ACTION TRANSMITTAL No. 2015-31

- Segment 1: 1,915 linear feet - Trail along Bailey Street from existing trail at 3rd Street to existing trail at 8th Street
- Segment 2: 1,870 linear feet – Trail along 10th Street East from existing trail at Progress Dr, crossing the Vermillion River, to existing trail in CP Adams Park
- Segment 3: 2,995 linear feet – Trail along Vermillion River from existing trail at western boundary of CP Adams Park to existing trail south of the Vermillion River trail bridge crossing

RE: Scope Change Request
Vermillion River Regional Greenway
City of Hastings

SCOPE CHANGE REQUEST

**Vermillion River Greenway
Hastings
2011 Project Scope**

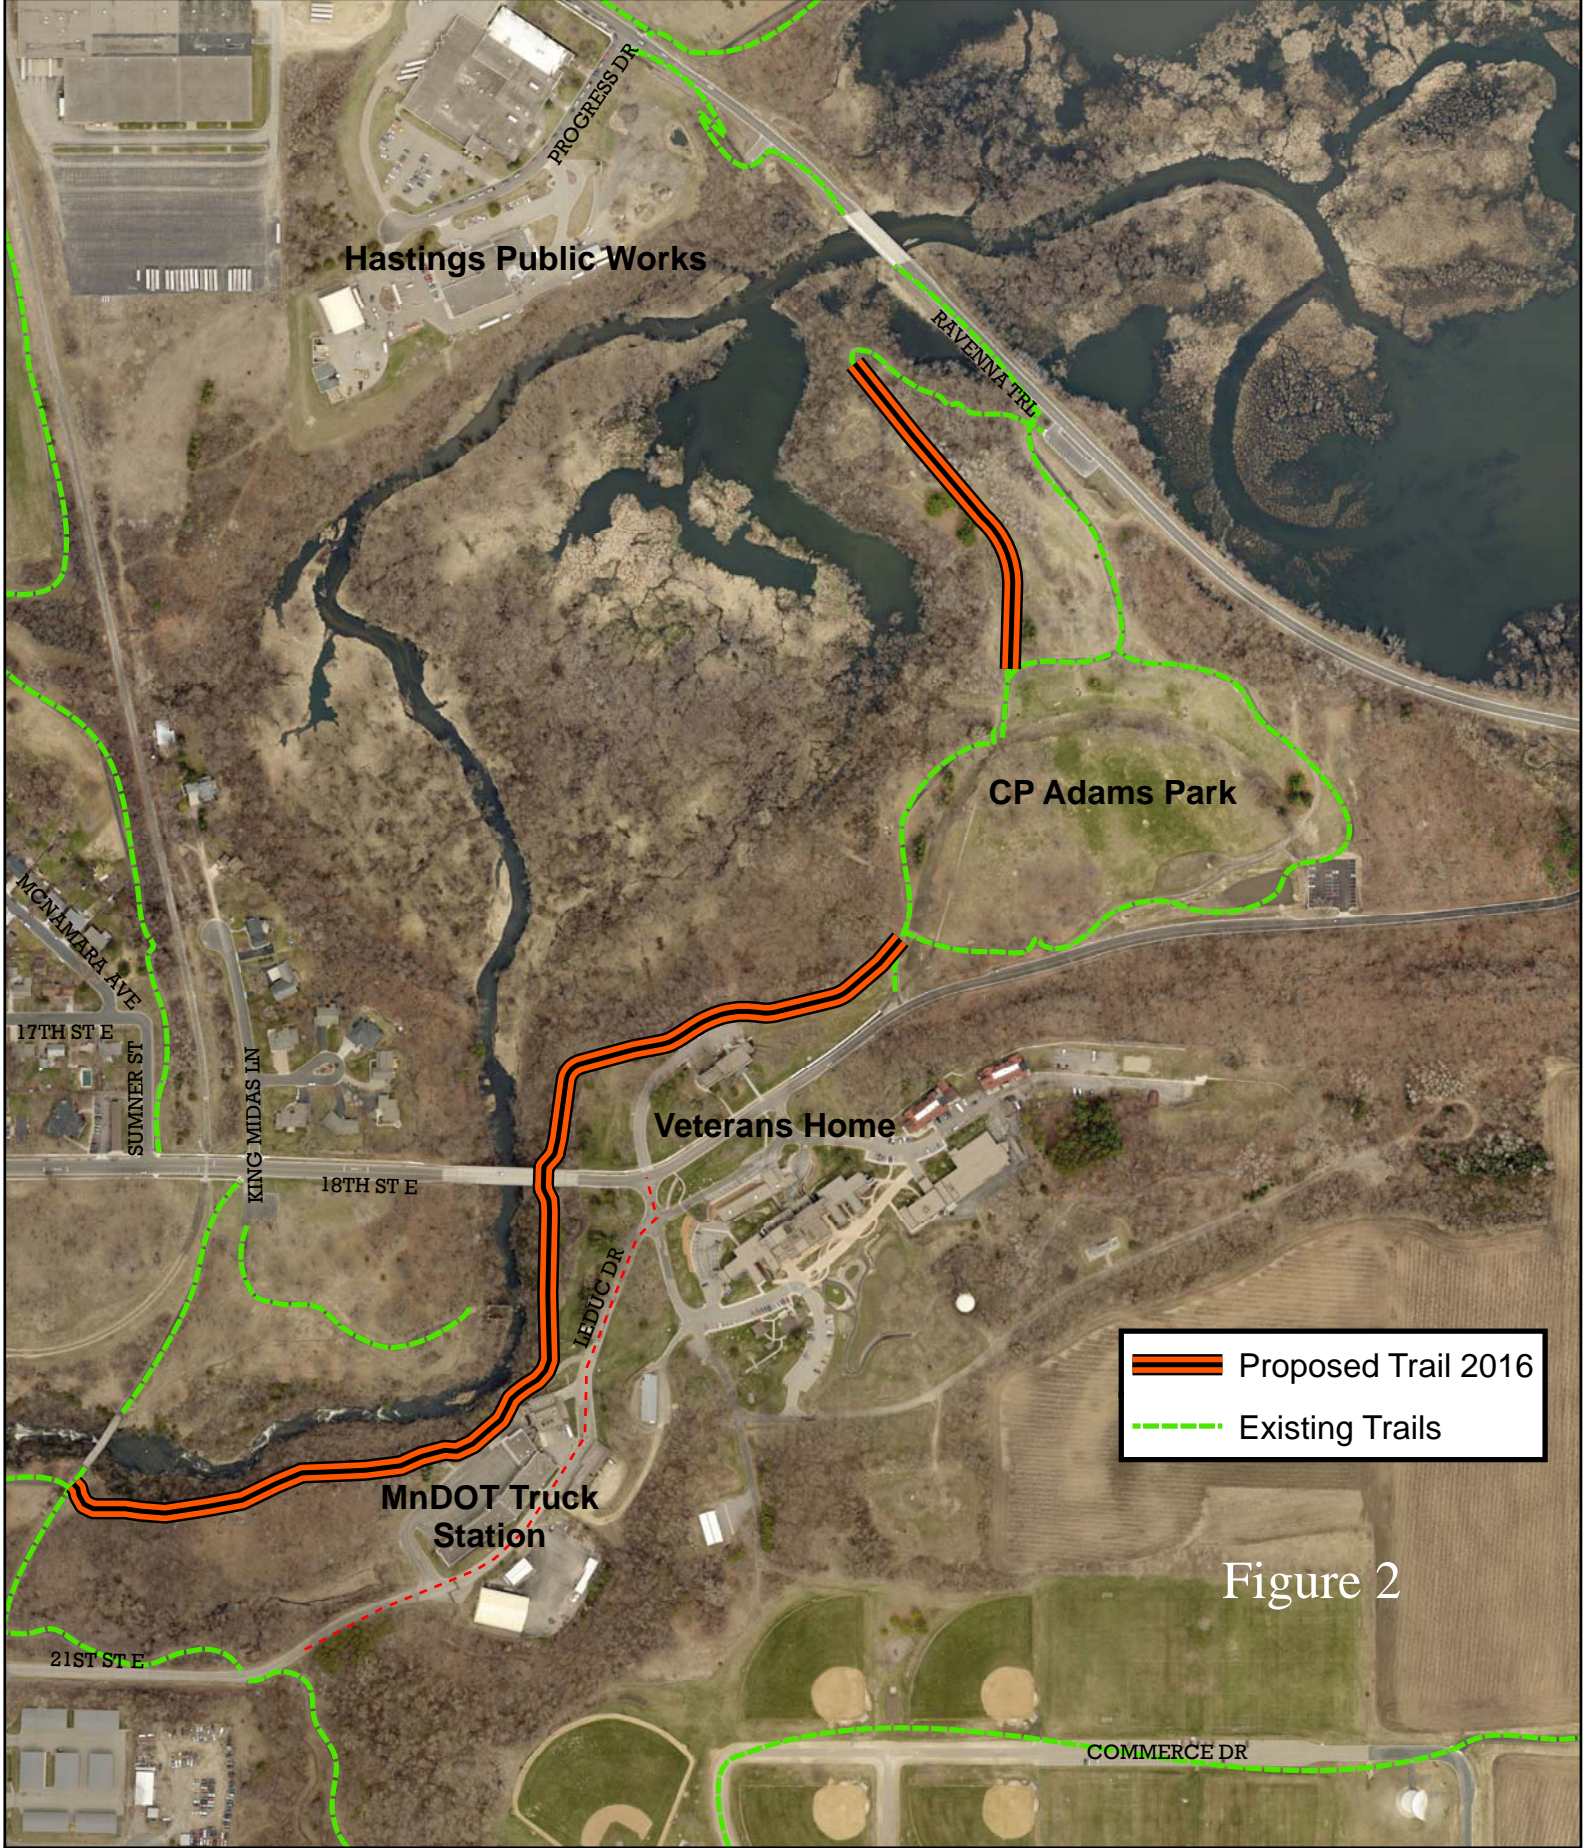
Figure 1: 2011 project as approved for funding in 2012

Figure 2: Proposed 2016 project

The following summarizes the proposed scope change:

1. Deletion of segment 1 in its entirety as described above;
2. Deletion of approximately 975 LF of segment 2

The project as proposed will now encompass construction of approximately 3,890 lineal feet of trail.
